Contract #: 04-0120F4
 Cty: SF/ALA Rte: 80 PM: 13.2/13.9
 File #: 69.25B

QUALITY ASSURANCE -- NON-CONFORMANCE REPORT

Location: Changxing Island, Shanghai, P.R. China **Report No:** NCR-000644
Prime Contractor: American Bridge/Fluor Enterprises, a JV **Date:** 20-Jan-2010
Submitting Contractor: Zhenhua Port Machinery Company, Ltd (ZPMC), Changxing Island **NCR #:** ZPMC-0615

Reference Description: MT Transverse Crack discovered after ZPMC tested and accepted this weld (7DW floorbeam to deck panel diaphragm joint)

Welding	Concrete	Other	
Welding	Curing	Procedural	Bridge No: 34-0006
Joint fit-up	Coating	Other	Component: 7DW Floor Beam to Deck Panel Diaphragm
Procedural	Procedural	Description: Missed MT transverse indication by QC

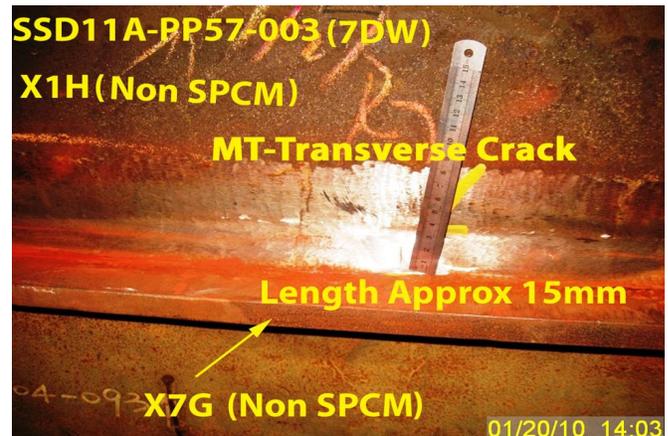
During the Quality Assurance Magnetic Particle Testing (MT) review of welds located on Segment 7DW, this Quality Assurance Inspector discovered the following issue:

- One (1) Transverse linear crack measuring approximately 15mm in length.
- The Y location is 4500mm from corner of the Panel Point PP57 at Cross Beam side.
- The indication is clearly marked on the material near the weld.
- The weld is identified as: SSD11A-PP57-003.
- This weld is a Complete Joint Penetration (CJP) weld joining the Deck Panel Diaphragm (X1H) to Floor Beam Flange (X7G).
- The Deck Panel Diaphragm (X1H) is identified as Non-Seismic Performance Critical Member (SPCM).
- The Floor Beam Flange (X7G) is identified as Non-SPCM.
- OBG segment 7DW is located outside North side of Bay 13.

The Notice of Witness Inspection Number (NWIT) is 005086. The indication is located inside an area that has been previously tested 100% and accepted by ZPMC Quality Control (QC) personnel.

Propose a resolution for the identified recurring non-conformance which constitutes a systematic problem on both materials/workmanship and quality control issues with revised procedures to remedy the defected work and to prevent future occurrences. A response for the resolution of this issue is expected within 14 days.

项目名称 Project Name:	美国海湾大桥 SFOBB	部件图号 Drawing No.:	BK1	报告编号 Report No.:	B-CWR102
合同号 Contract No.:	04-0120F4	部件名称 Item Name:	DBG CANTILEVER BOX BRACKET	NDT 报告编号 NDT Report No.:	B787-MT-174
项目编号 Project No.:	ZP06-787

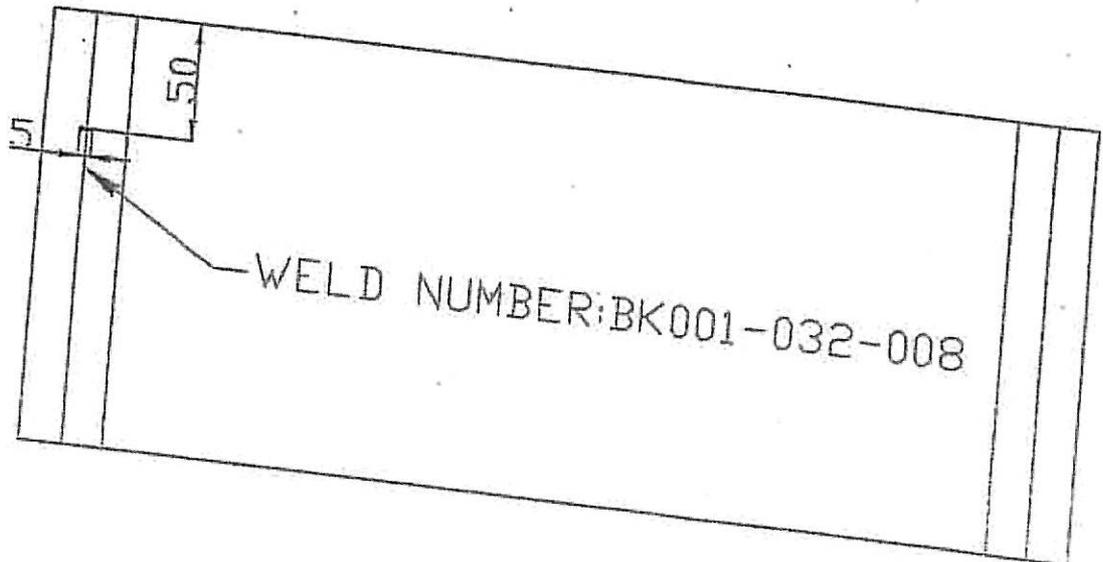
One transverse crack was found by use of MT on BK001-032-008.

2. QC and a Lead CWI shall have an approved copy of the CWR in hand prior to the repair.
3. Remove paint ≥ 25 mm in all direction of HAZ prior to MT.
4. Clean the excavation area of all loose debris including MT powder. Preheat to 65° C before removing cracks by grinding, repair area shall extend a minimum of 50mm beyond each end of single crack repairs.

6. Prepare excavation in accordance with the New Repair Procedure prior to welding.
7. Before this repair, Verify with VT and MT repair areas are defects free, and also MT shall be performed on the base metal laying abroad cracks to ensure that no cracks were propagated to the base metal. Separate CWR approval is needed if cracks are found in the base metal, and only after this new CWR's approval can continue the repair.

项目名称 Project Name	美国海湾大桥 SFOBB	部件图号 Drawing No	CB202A	报告编号 Report No.	B-WR10060
合同号 Contract No.	04-0120F4	部件名称 Items Name	CB16 STRUT	NDT报告编号 Report No. of NDT	B787-UT-10854
项目编号 Project No.:	ZP06-787

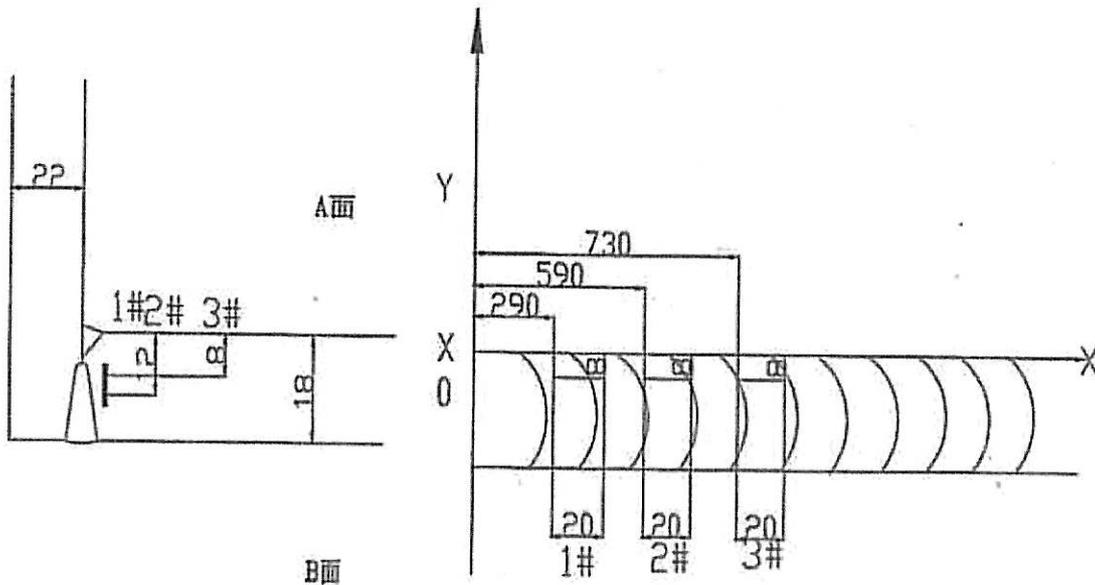
Rejected indication found by ultrasonic inspection is less than the maximum allowance aggregate length.

1. 从缺陷距离端面较近一侧 ($D \leq 0.65T$, D为缺陷深度, T为板厚) 采用碳锉或打磨的方法去除焊缝缺陷;
 2. 参照返修焊接工艺规程 (WPS) 准备正确的接头型式, 预热和焊接;
 3. 焊前对修补区域进行VT检测保证缺陷完全被清除;
 4. 将修补区域打磨到与母材或邻近焊缝平齐;
 5. 根据批准的车间图纸检查焊缝.
-
1. Gouge or grind from nearer side from metal edge ($D \leq 0.65T$, "D" is depth of defects, "T" is thickness of metal) to remove all defects;
 2. Follow repair WPS for joint preparation, preheat, and weld deposit;
 3. Verify with VT no defects remain in the weld joint prior to welding;
 4. Grind the repaired area flush with base metal or the adjacent weld;
 5. Check the welds according to the working drawings;

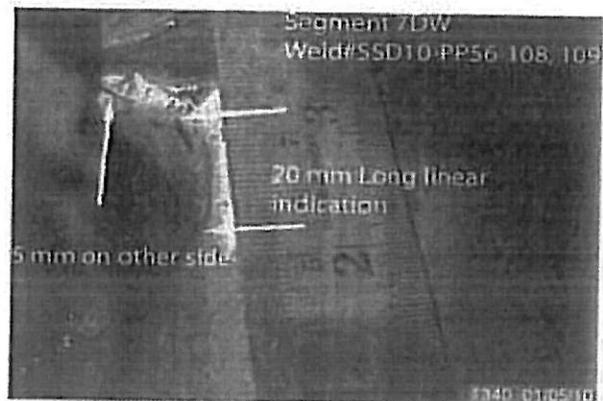
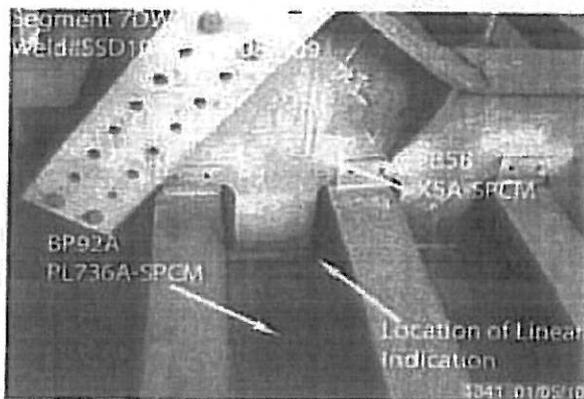
-One (1) Longitudinal linear indication measuring approximately 20mm in length.

-The welds are identified as: SSD10-PP56-108, 109.

-These welds are a Fillet Weld type joining the Bottom Plate (BP92A) to Floor Beam (FB5B) web plate.

-These welds are designated as Seismic Performance Critical Member (SPCM) on the approved drawing (SEGSD10).

Propose a resolution for the identified non-conformance with revised procedures to prevent future occurrences. Provide the training and equipment required for the ZPMC MT technician such that these indications are found. A response for the resolution of this issue is expected within 7 days.

项目名称 Project Name:	美国海湾大桥 SFOBB	部件图号 Drawing No.:	SSD10	报告编号 Report No.:	B-CWR1043
合同号 Contract No.:	04-0120F4	部件名称 Item Name:	OBG FLOOR BEAM AND BOTTOM PLAT E	NDT 报告编号 NDT Report No.:	B787-MT-17605
项目编号 Project No.:	ZP06-787

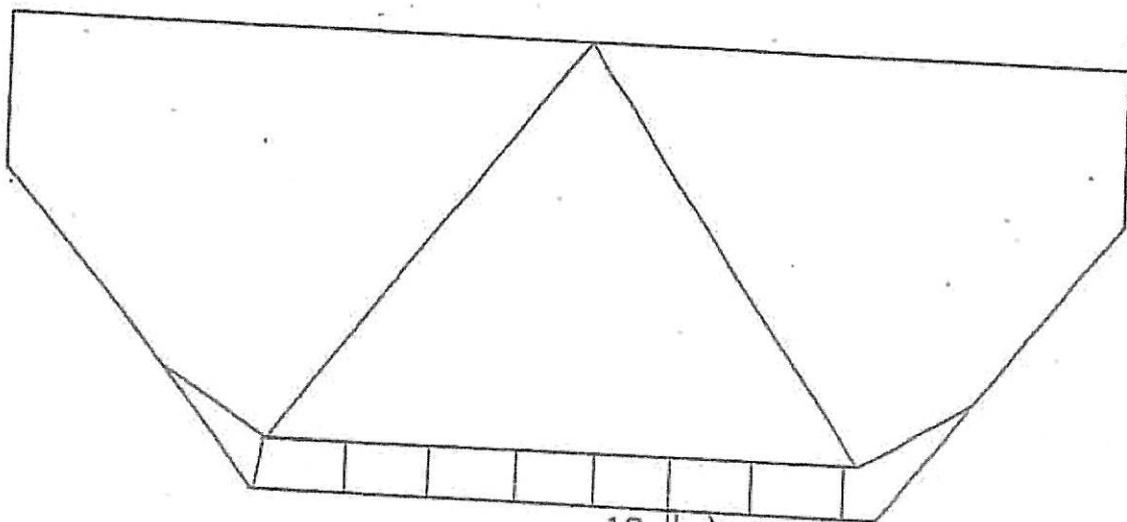
One longitudinal crack was found by use of MT on SSD10-PP56-108.

2. QC and a Lead CWI shall have an approved copy of the CWR in hand prior to the repair.
3. Remove paint ≥25mm in all direction of HAZ prior to MT.
4. Clean the excavation area of all loose debris including MT powder. Preheat to 65° C before removing cracks by grinding, repair area shall extend a minimum of 50mm beyond each end of single crack repairs.

6. Prepare excavation in accordance with the New Repair Procedure prior to welding.
7. Before this repair, Verify with VT and MT repair areas are defects free, and also MT shall be performed on the base metal laying abroad cracks to ensure that no cracks were propagated to the base metal. Separate CWR approval is needed if cracks are found in the base metal, and only after this new CWR's approval can continue the repair.

项目名称 Project Name:	美国海湾大桥 SFOBB	部件图号 Drawing No.:	SSD11	报告编号 Report No.:	B-CWR1044
合同号 Contract No.:	04-0120F4	部件名称 Item Name:	OBG FLOOR BEAM AND BOTTOM PLAT E 7DW	NDT 报告编号 NDT Report No.:	B787-MT-1760
项目编号 Project No.:	ZP06-7B7

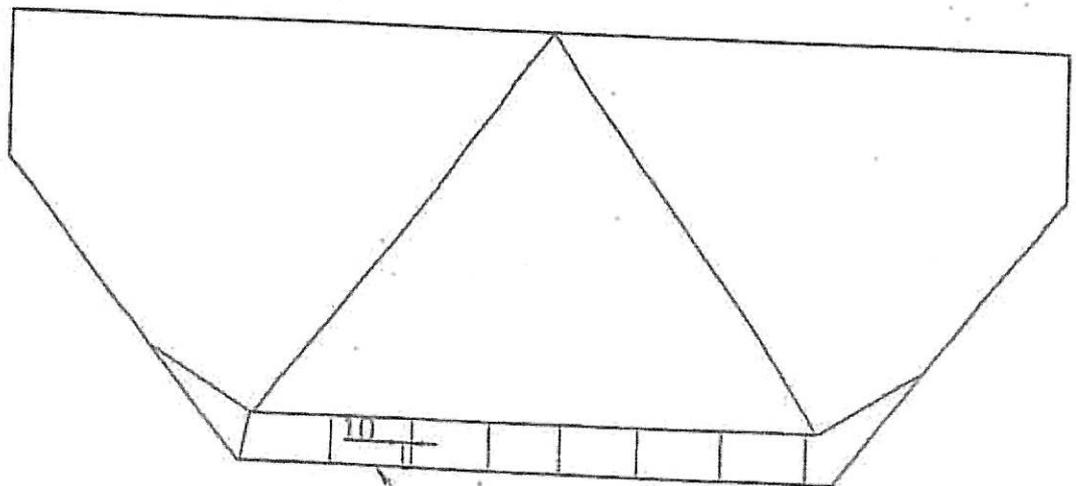
One longitudinal crack was found by use of MT on SSD11-PP57-0B4.

2. QC and a Lead CWI shall have an approved copy of the CWR in hand prior to the repair.
3. Remove paint ≥ 25 mm in all direction of HAZ prior to MT.
4. Clean the excavation area of all loose debris including MT powder. Preheat to 65° C before removing cracks by grinding, repair area shall extend a minimum of 50mm beyond each end of single crack repairs.

6. Prepare excavation in accordance with the New Repair Procedure prior to welding.
7. Before this repair, Verify with VT and MT repair areas are defects free, and also MT shall be performed on the base metal laying abroad cracks to ensure that no cracks were propagated to the base metal. Separate CWR approval is needed if cracks are found in the base metal, and only after this new CWR's approval can continue the repair.

项目名称 Project Name:	美国梅湾大桥 SFOBB	部件图号 Drawing No.:	SSD11	报告编号 Report No.:	B-CWR1
合同号 Contract No.:	04-0120F4	部件名称 Item Name:	BCW FLOOR BEAM SPLICE	NDT 报告编号 NDT Report No.:	B787-MT-1
项目编号 Project No.:	ZP06-787

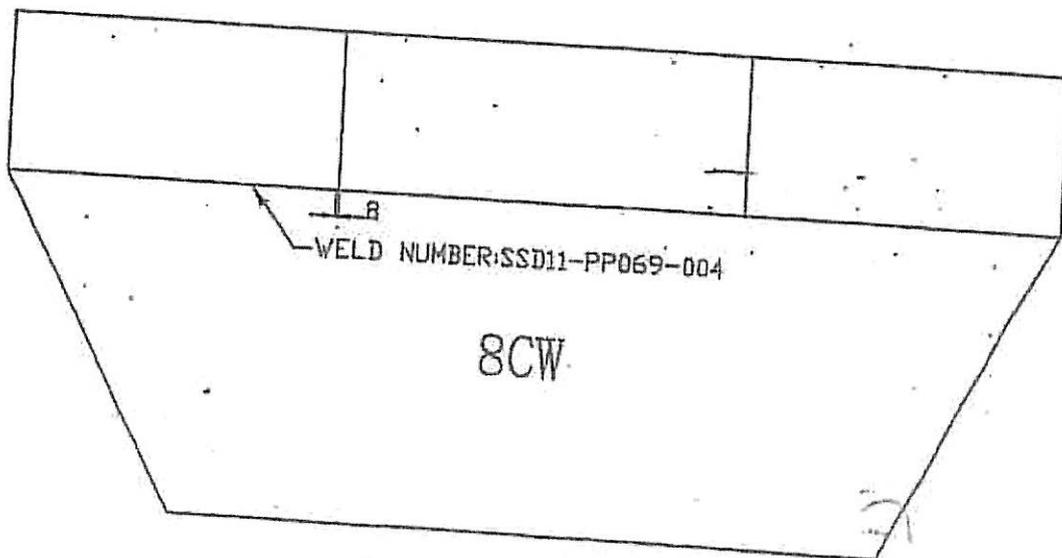
One longitudinal crack was found by use of MT on SSD11-PP69-004.

2. QC and a Lead CWI shall have an approved copy of the CWR in hand prior to the repair.
3. Remove paint ≥ 25 mm in all direction of HAZ prior to MT.
4. Clean the excavation area of all loose debris including MT powder. Preheat to 85° C before removing cracks by grinding, repair area shall extend a minimum of 50mm beyond each end of single crack repairs.

6. Prepare excavation in accordance with the New Repair Procedure prior to welding.
7. Before this repair, Verify with VT and MT repair areas are defects free, and also MT shall be performed on the base metal laying abroad cracks to ensure that no cracks were propagated to the base metal. Separate CWR approval is needed if cracks are found in the base metal, and only after this new CWR's approval can continue the repair.

Joint fit-up Coating Other Component: 7DW Floor Beam to Deck Panel Diaphragm

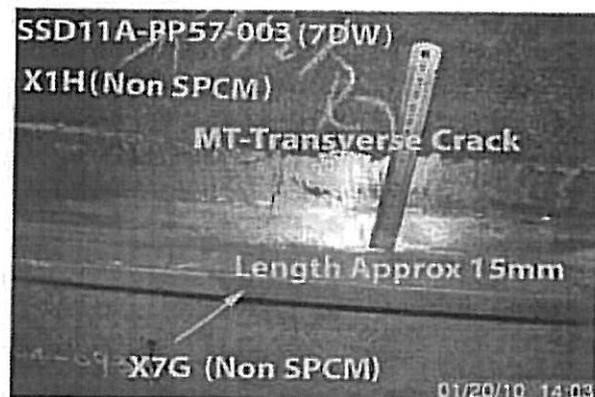
Reference Description: MT Transverse Crack discovered after ZPMC tested and accepted this weld (7DW floorbeam to deck panel diaphragm joint)

Propose a resolution for the identified recurring non-conformance which constitutes a systematic problem on both materials/workmanship and quality control issues with revised procedures to remedy the defected work and to prevent future occurrences. A response for the resolution of this issue is expected within 14 days.

项目名称 Project Name:	美国海湾大桥 SFOBB	部件图号 Drawing No.:	SEG039	报告编号 Report No.:	B-CWR1167
合同号 Contract No.:	04-0120F4	部件名称 Item Name:	DBG DECK PLATE SPlice 7BW	NDT 报告编号 NDT Report No.:	B787-MT-18475
项目编号 Project No.:	ZP06-787

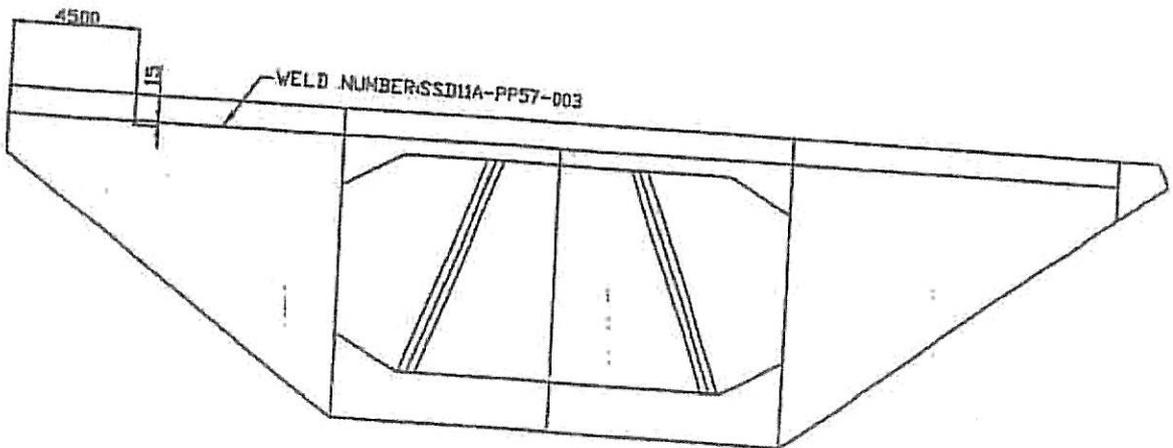
One transverse crack was found by use of MT on SSD11A-PP57-003.

14. 返修后根据图纸进行VT, UT和MT检测, 并按照合同10-1.59 "钢结构" 中的 "检测和试验" 要求进行附加MT检测.
1. QC and a Lead CWI shall be present, direct and supervise all grinding and welding operations during this repair to ensure the repair is per the disposition requirements.

2. QC and a Lead CWI shall have an approved copy of the CWR in hand prior to the repair.
 3. Remove paint ≥ 25 mm in all direction of HAZ prior to MT.
 4. Clean the excavation area of all loose debris including MT powder. Preheat to 65° C before removing cracks by grinding and it applied to all the repair process. Repair area shall extend a minimum of 50mm beyond each end of single crack repairs,

7. Before this repair, Verify with VT and MT repair areas are defects free, and also MT shall be performed on the base metal laying around cracks to ensure that no cracks were propagated to the base metal. Separate CWI approval is needed if cracks are found in the base metal, and only after this new CWR's approval can continue the repair.

NCR #: ZPMC-0622

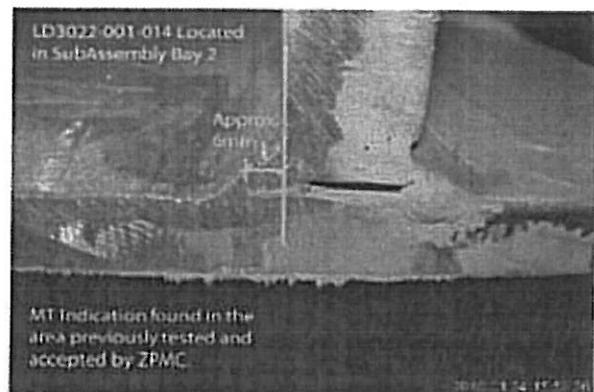
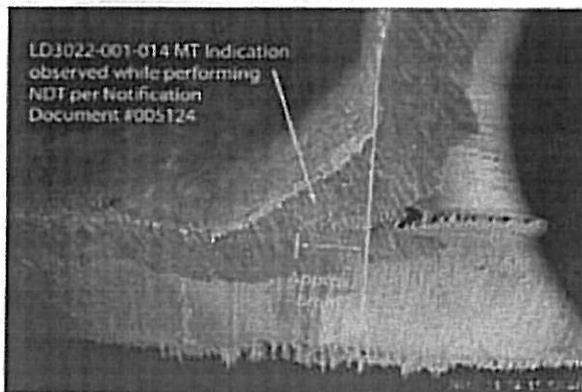
Reference Description: Missed MT Indication by QC for a weld joint on the Lift 12 Longitudinal Shear Plate

Propose a resolution for the identified recurring non-conformance which constitutes a systematic problem on both materials/workmanship and quality control issues with revised procedures to remedy the defected work and to prevent future occurrences. A response for the resolution of this issue is expected within 14 days.

项目名称 Project Name:	美国海湾大桥 SFOBB	部件图号 Drawing No.:	LD3022	报告编号 Report No.:	B-CWR1151
合同号 Contract No.:	04-0120F4	部件名称 Item Name:	12 th lifting longitudinal diaphragm	NDT 报告编号 NDT Report No.:	B787-MT-17930
项目编号 Project No.:	ZP06-787

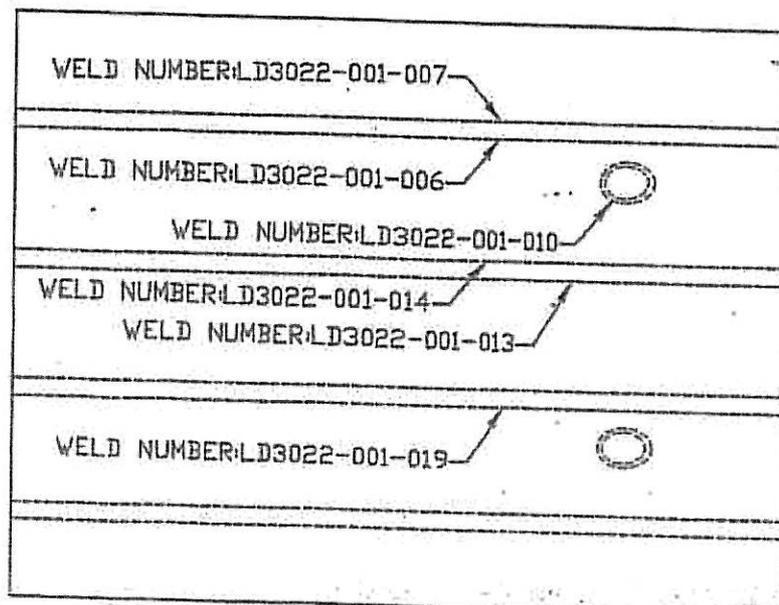
One pore and two transverse cracks were found by use of MT on LD3022-001-006.
One longitudinal crack and four transverse cracks were found by use of MT on LD3022-001-007.
One pore and one transverse crack were found by use of MT on LD3022-001-010.
One pore and two transverse cracks were found by use of MT on LD3022-001-013.
One longitudinal crack and one transverse crack were found by use of MT on LD3022-001-014.
One pore and one transverse crack were found by use of MT on LD3022-001-019.

2. QC and a Lead CWI shall have an approved copy of the CWR in hand prior to the repair.
3. Remove paint ≥ 25 mm in all direction of HAZ prior to MT.
4. Clean the excavation area of all loose debris including MT powder. Preheat to 65° C before removing cracks by grinding, repair area shall extend a minimum of 50mm beyond each end of single crack repairs, and 50mm beyond the outermost cracks for multiple crack repairs

6. Prepare excavation in accordance with the New Repair Procedure prior to welding.
7. Before this repair, Verify with VT and MT repair areas are defect free, and also MT shall be performed on the base metal laying abroad cracks to ensure that no cracks were propagated to the base metal. Separate CWR approval is needed if cracks are found in the base metal, and only after this new CWR's approval can continue the repair.
